3.5L GTDI—INTERMITTENT STUMBLE/MISFIRE ON ACCELERATION FROM HIGHWAY CRUISE IN HUMID OR DAMP CONDITIONS WITH POSSIBLE DTC P0304, P0305, P0306, OR P0430

TSB 13-8-1

2011-2012 F-150

This article supersedes TSB **13-3-3** to update the Service Procedure and Part List.

Figure 1 - Article 13-8-1

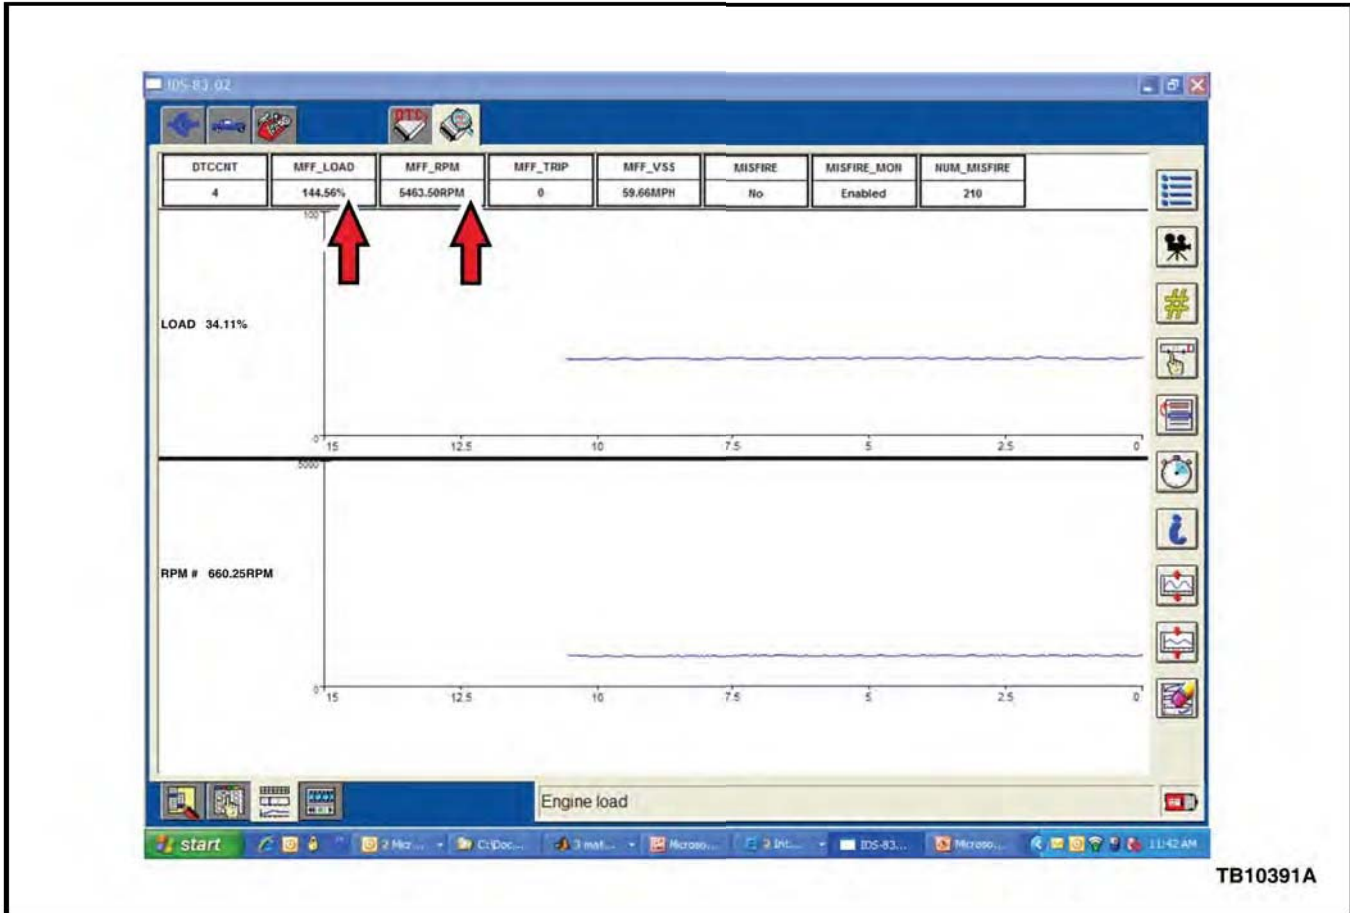
- a. Select Toolbox
 - b. Then Data Logger
 - c. Then Modules
 - d. Then PCM
 - e. Next, select the following PIDs: MFF_LOAD and MFF_RPM.
2. Is the misfire concern only repeatable in humid or damp conditions?
 - a. Yes - Proceed to Step 3.
 - b. No - This article does not apply. Refer to Powertrain Control/Emissions Diagnosis (PC/ED) Manual Section 3: Powertrain Symptom Index to inspect such areas as Ignition, Compression, and Injection.
 3. Does the Misfire Freeze Frame Data indicate engine speed above 2500 rpm and load 100% or above? (Figure 1)

- a. Yes - Proceed to Step 4.
 - b. No - This article does not apply. Refer to PC/ED Manual Section 3: Powertrain Symptom Index to inspect such areas as Ignition, Compression, and Injection.
4. Is vehicle equipped with latest level charge air cooler, engineering part number BL34-9L440-AE? (Figure 2)

Figure 2 - Article 13-8-1

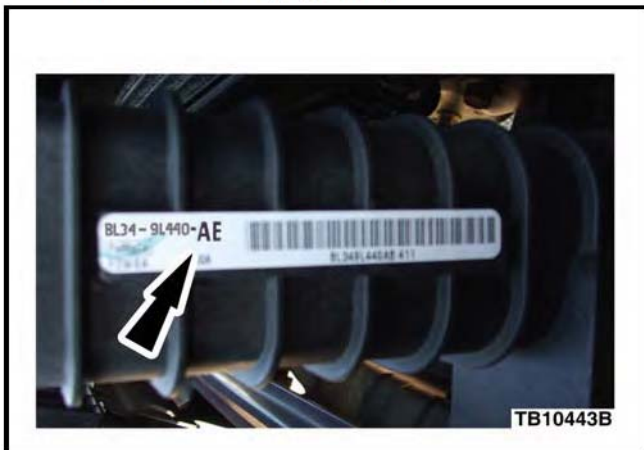
CARE NEEDS TO BE TAKEN NOT TO INSTALL THE REVISED BOTTOM AIR DEFLECTOR ONTO CHARGE AIR COOLER ENGINEERING PART BL34-9L440-AE AS IT WILL RESULT IN HIGHER MANIFOLD AIR CHARGE TEMPERATURES AND SIGNIFICANT LOSS OF ENGINE PERFORMANCE.

- a. Yes - This article does not apply. Refer to PC/ED Manual Section 3: Powertrain Symptom Index to inspect such areas as Ignition, Compression, and Injection.
- b. No - Proceed to Step 5.

Figure 3 - Article 13-8-1

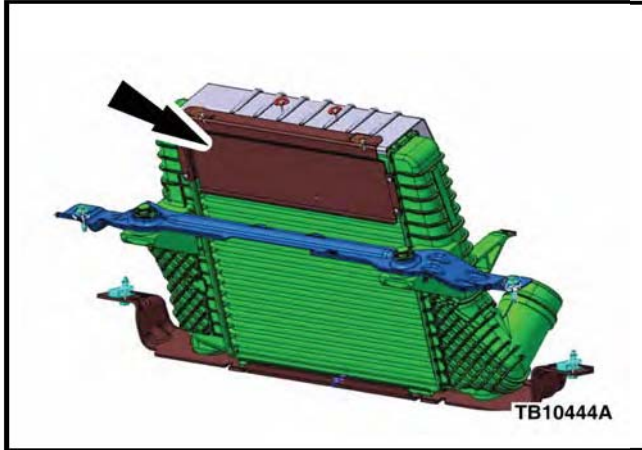
- 5. Is DTC P0430 present?
 - a. Yes - replace the left hand catalytic converter. Refer to Workshop Manual (WSM), Section 309-00. Proceed to Step 6.
 - b. No - Proceed to Step 6.
- 6. Is the Charge Air Cooler equipped with the top air deflector? (Figure 3)

- a. Yes - remove and discard. Refer to WSM, Section 303-12. Proceed to Step 7.
 - b. No - Proceed to Step 7.
7. Install revised bottom air deflector.
- a. Make sure that the lower forward facing bottom seven (7) tubes and eight (8) rows of fins on the Charge Air Cooler are dry and free of dirt and debris. (Figure 4)
